Exelon Generation Company, LLC

Braidwood Station, Unit 2
Facility Operating License No. NPF-77
NRC Docket No. STN 50-457

Subject: Response to Request for Additional Information Regarding the Steam Generator Tube Inspection Report for Braidwood Station, Unit 2, Refueling Outage 17

Response to Request for Additional Information
Regarding the Steam Generator Tube Inspection Report for Braidwood Station, Unit 2 Refueling Outage 17

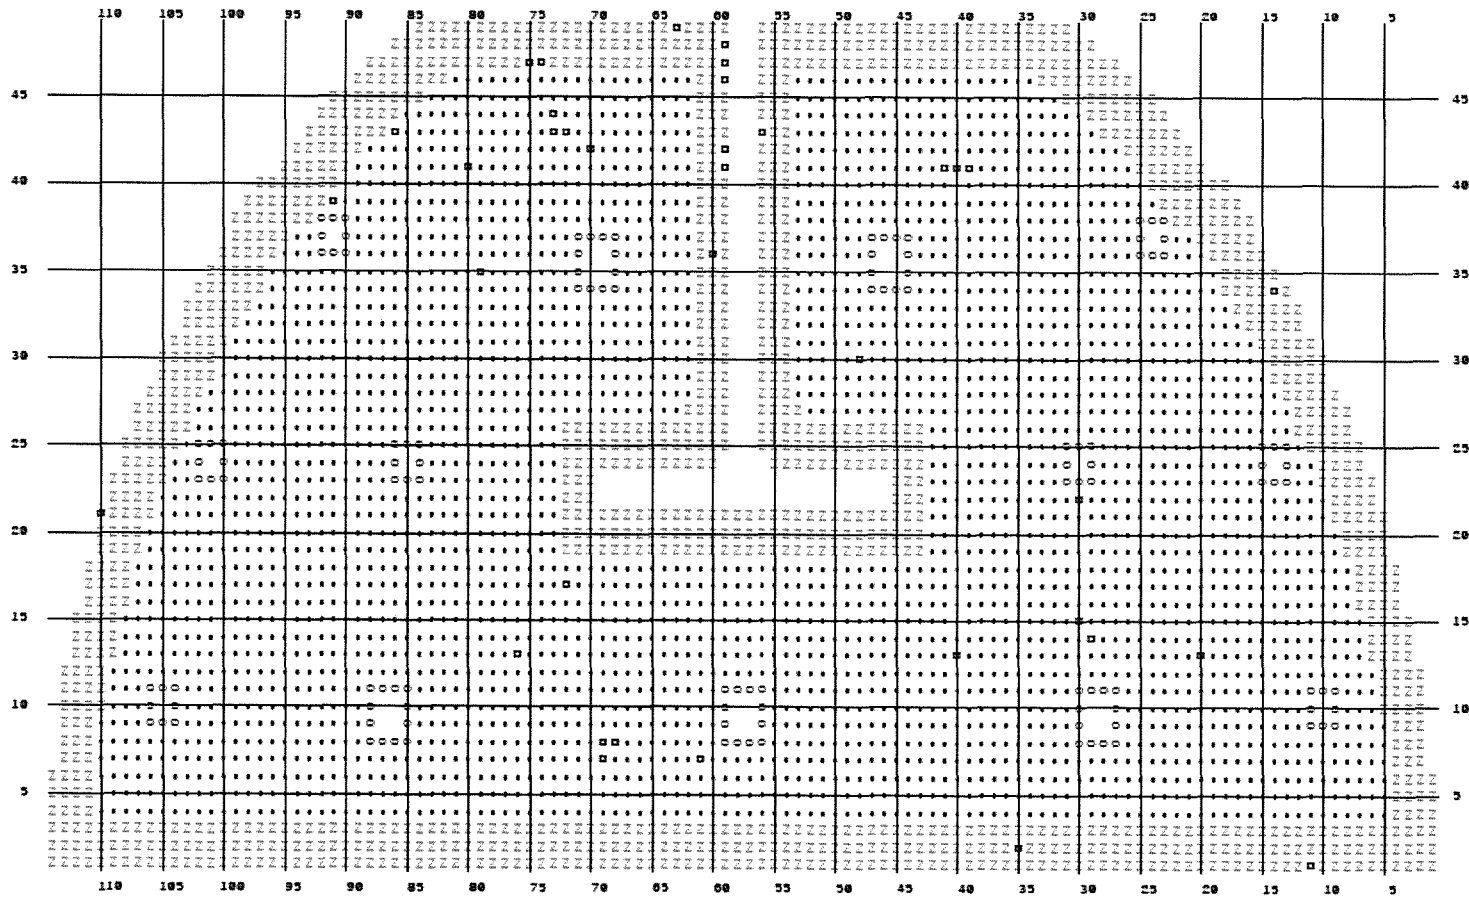
Your November 14, 2014, submittal indicated that three tubes deep around the entire periphery, including the no tube lane and T-slot, were inspected in all four SGs with an X-probe. Clarify the axial extent of these exams (e.g., tube-end to tube-end, H distance to first support on both hot-leg and cold-leg). Discuss whether or not these exams included both hot-leg and cold-leg regions.*

The axial extent was the tube end to flow distribution baffle (1st Tube Support Plate (TSP) -01C or 01H) for the entire periphery scope, including the no tube lane and T-slot. In the "head" of the T-slot on the hot leg, the extent of the exam was extended from 01H to 03H. The exams included both the hot leg and cold leg regions. This is shown in the attached tube sheet maps in Attachment B.
